X23-575_867_603___GEO_EN_005___RVTO_MARCO_LUNETA__B-GUSS_KW29___170714_SE376_ACC_141020_003.CATPart

Analyze made against this part file name.

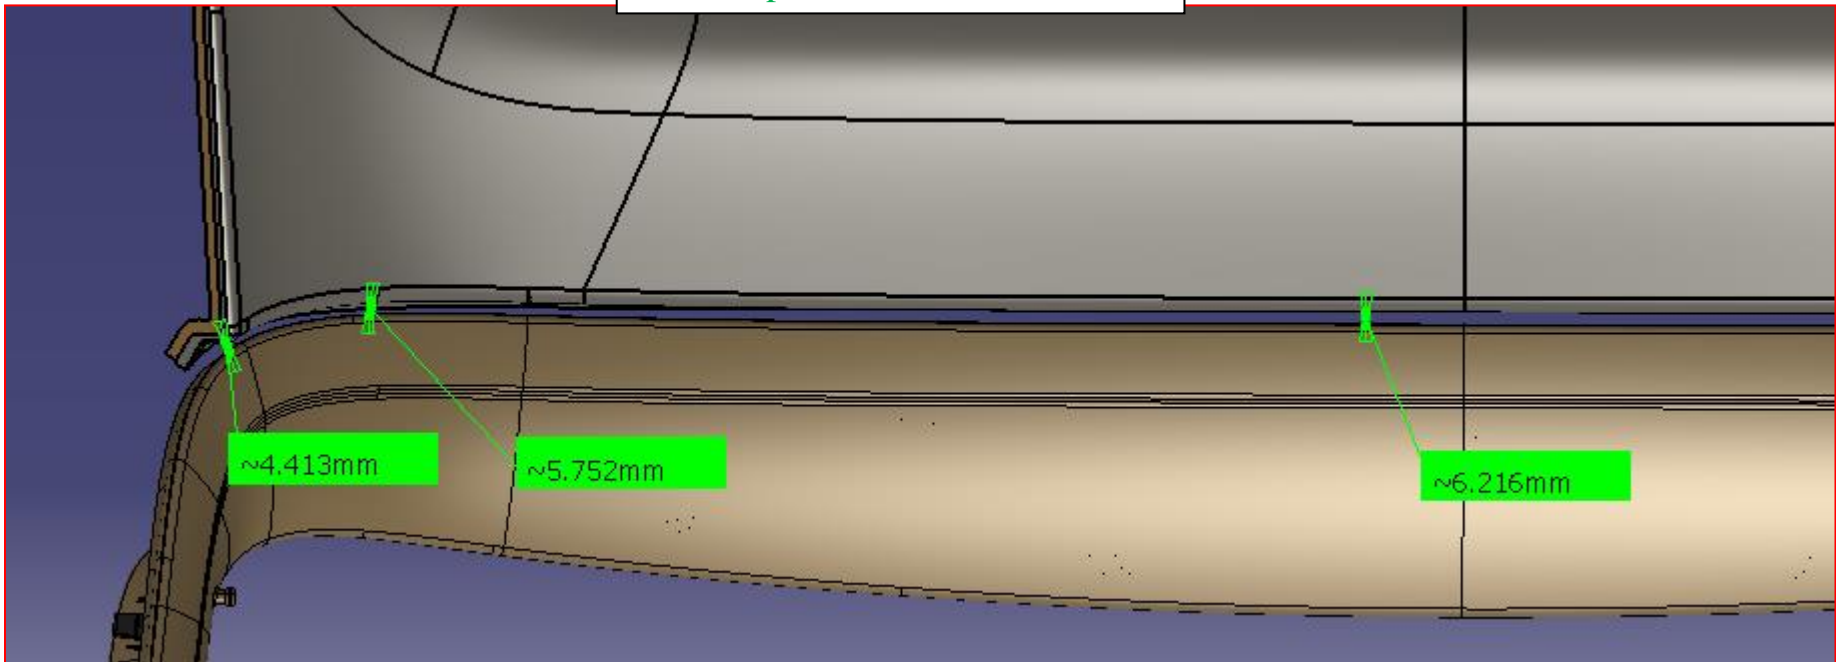
Not constant gap with roof linner

We have to follow the strak, roof will be updated

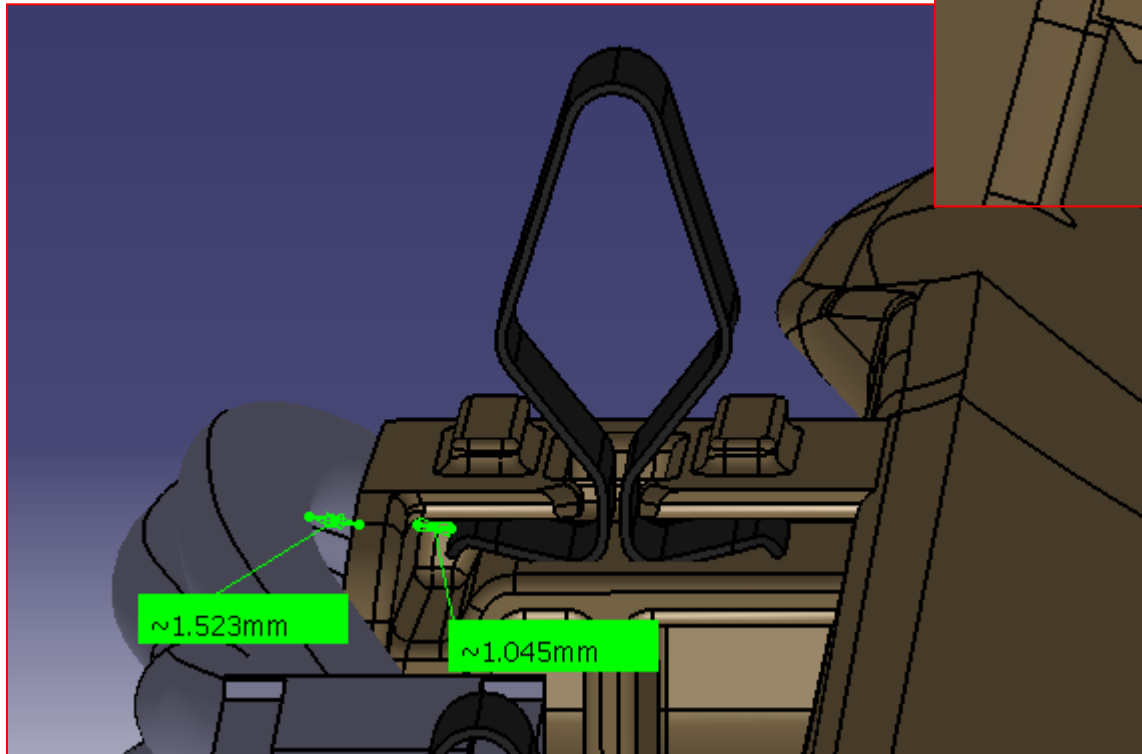
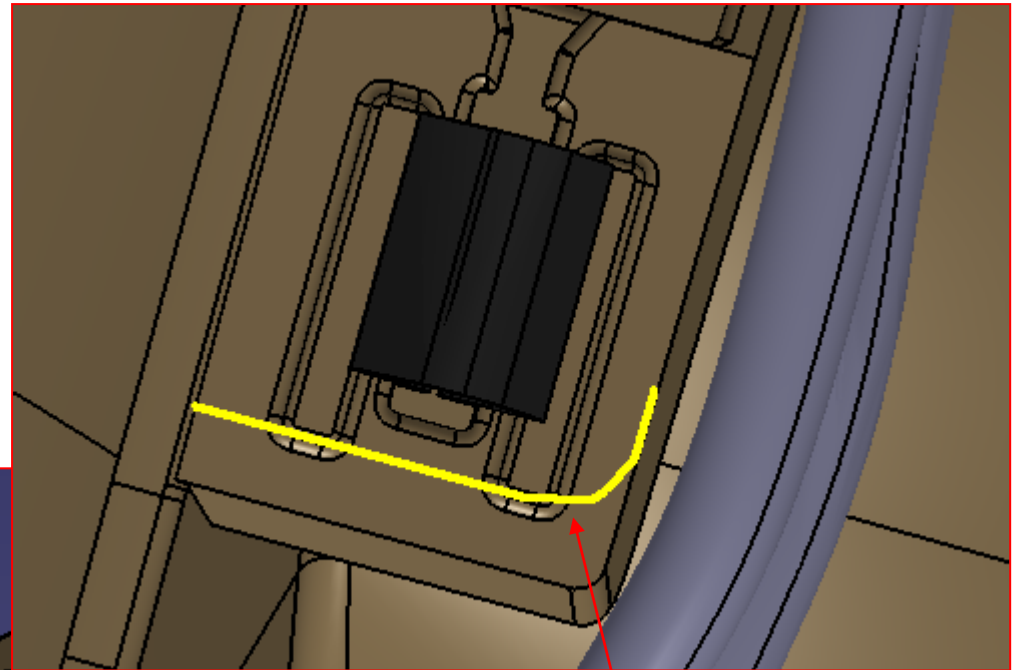
Should we try to reach the yellow limit?

Please, try to get a minimum of 2mm gap with cords.

Yesterday I got an updated electrical cords from Seat. I will inform Cristian about the folder of this information.

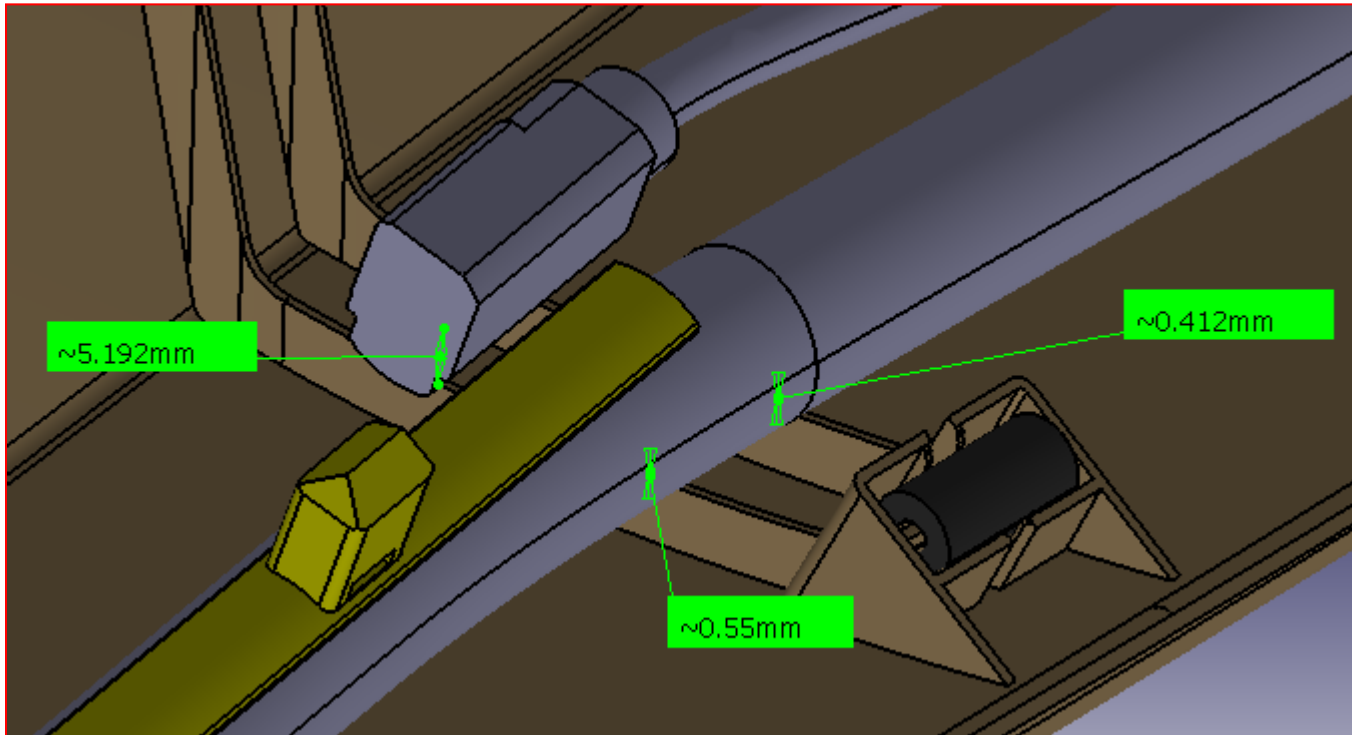
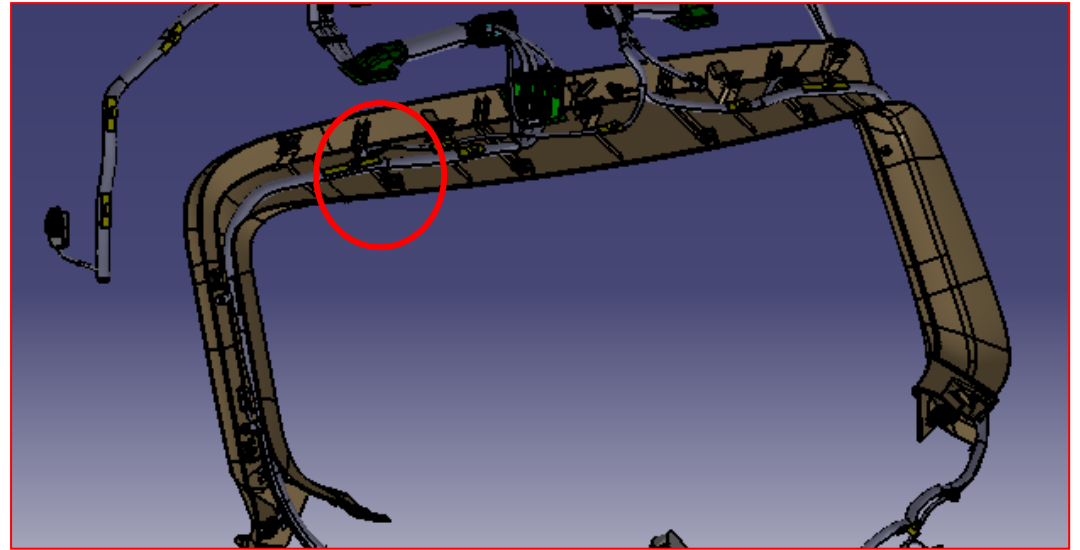
*Please specify the correct gap
(rib high constant 5mm).*

Please, try to get a minimum of 3mm gap
between cords and ribs

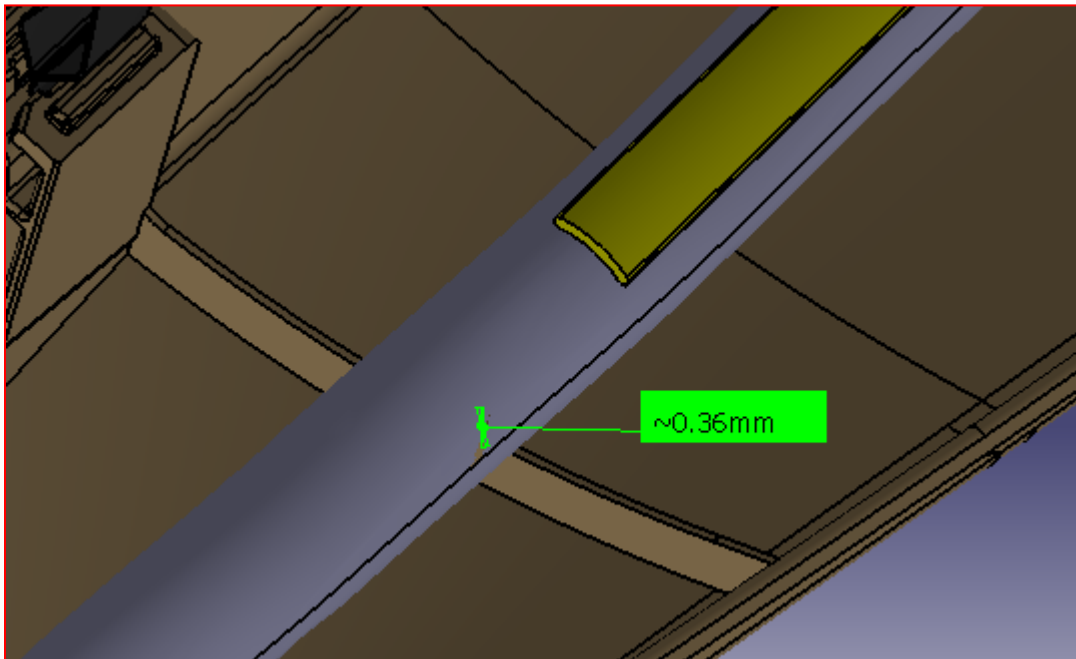
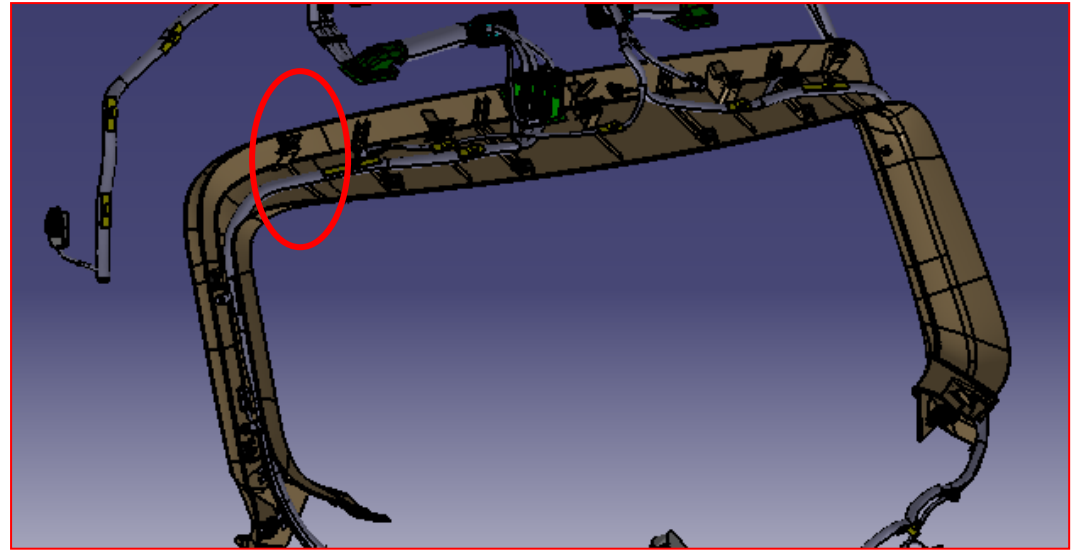
*Please specify the correct gap
(rib high constant 5mm).*

Please, try to get a minimum of 3mm gap
between cords and ribs

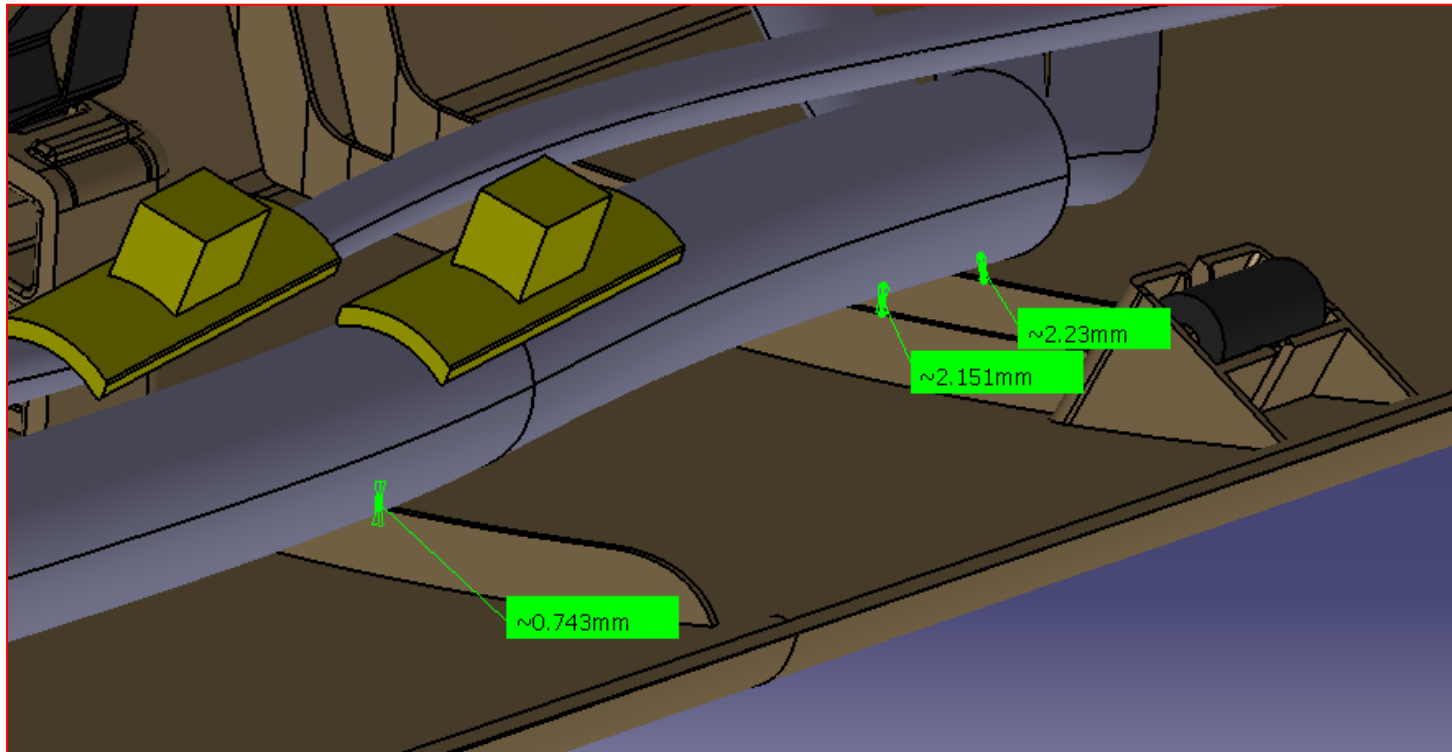
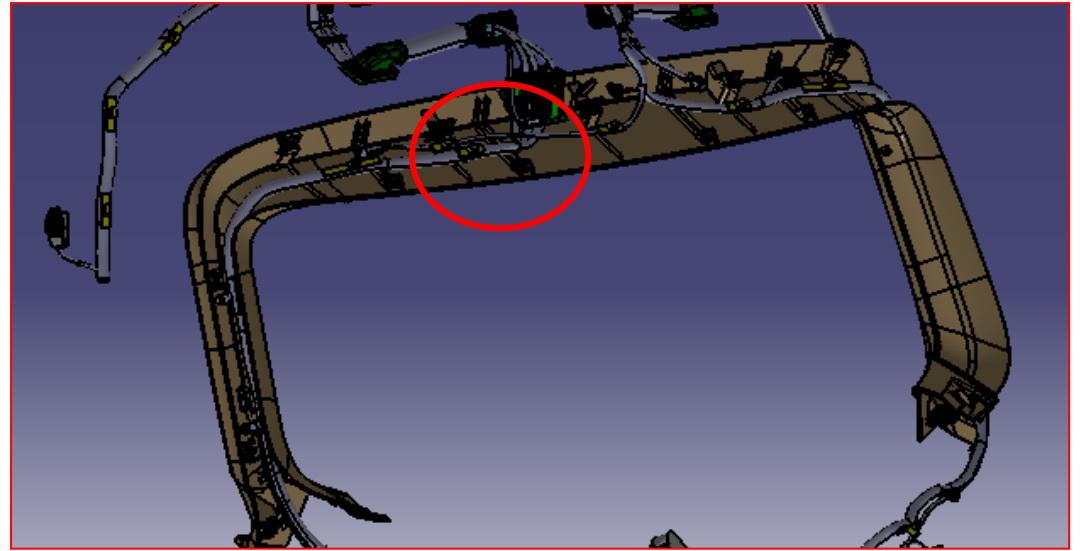
*Please specify the correct gap
(rib high constant 5mm).*

Please, try to get a minimum of 3mm gap
between cords and ribs

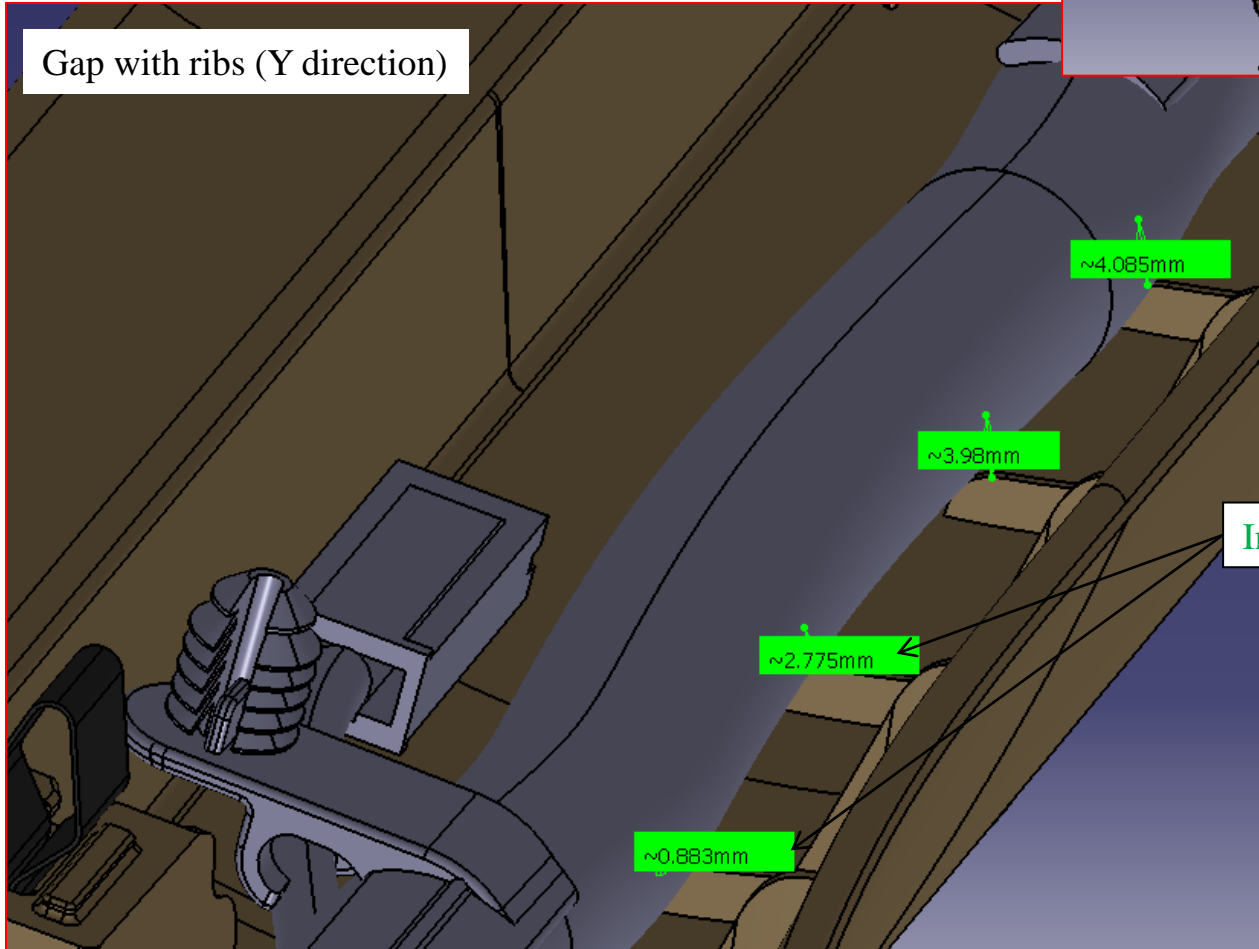
*Please specify the correct gap
(rib high constant 5mm).*

Gap with ribs (Y direction)

Increase these gaps to 3mm. Minimum gap

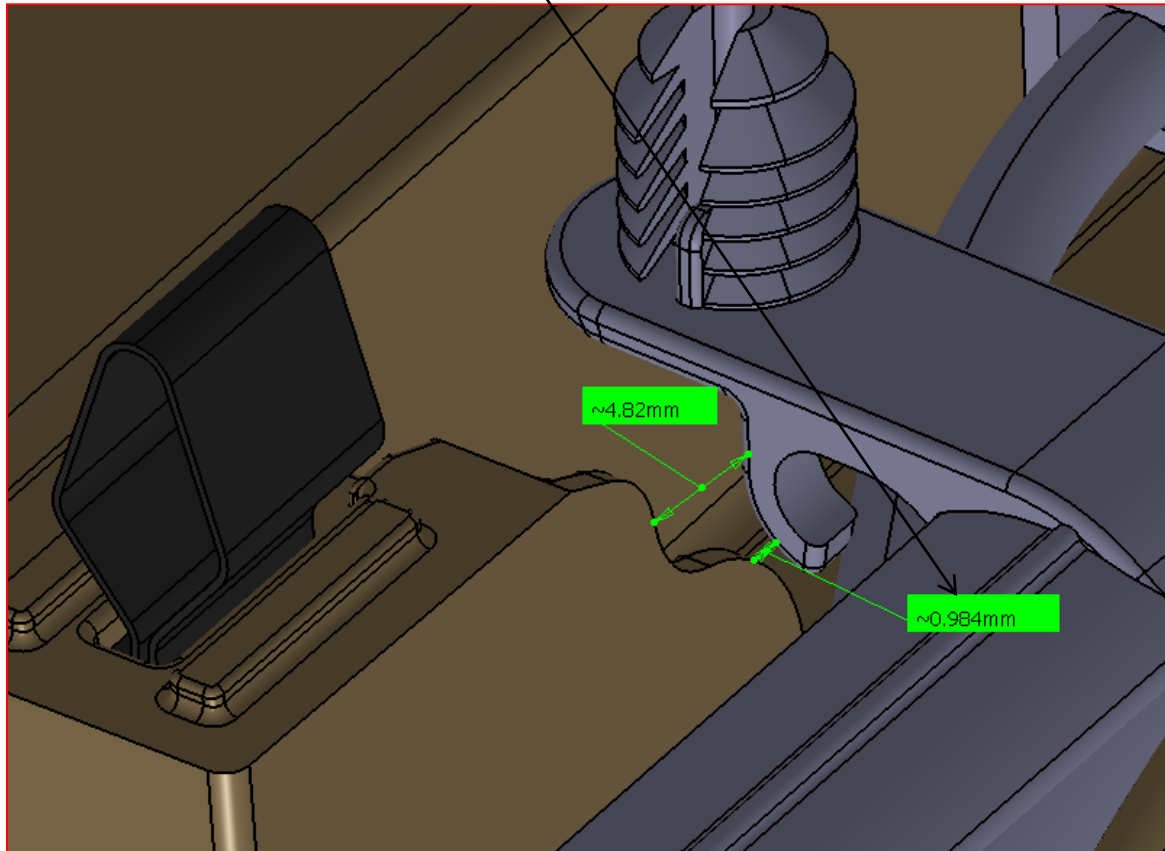
*Please specify the correct gap
(rib high constant 5mm).*

Increase this gap (2mm.)

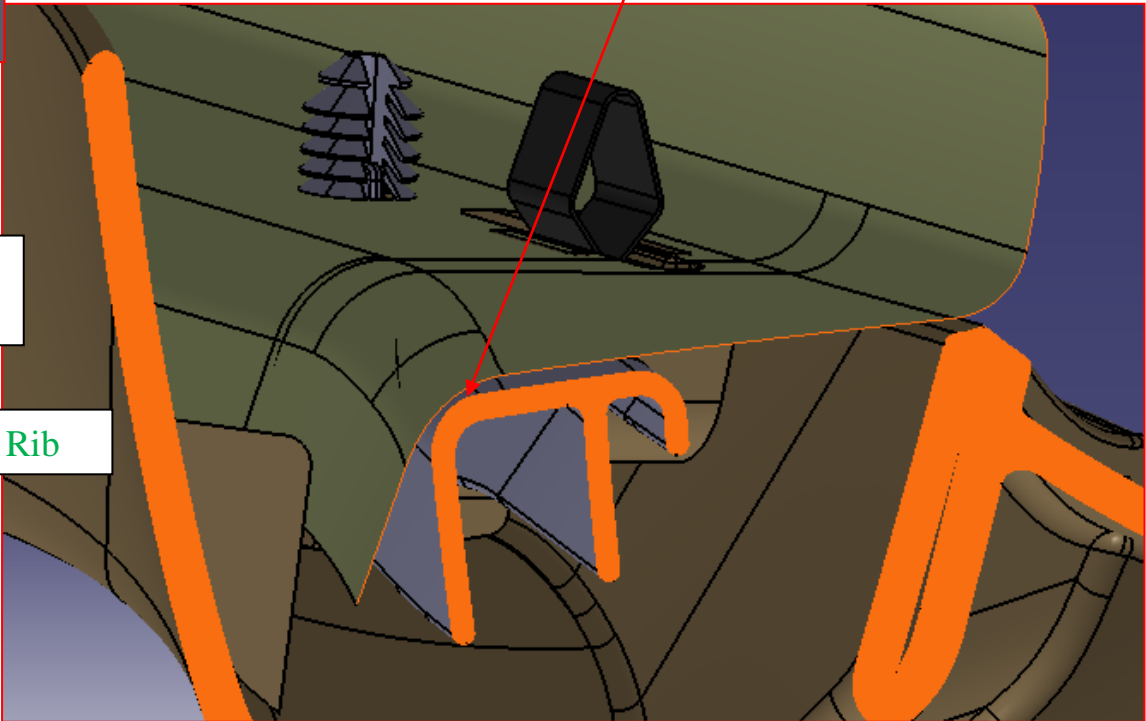
??? - do we have the last INNENTEIL?
Contact gulotte - BIW
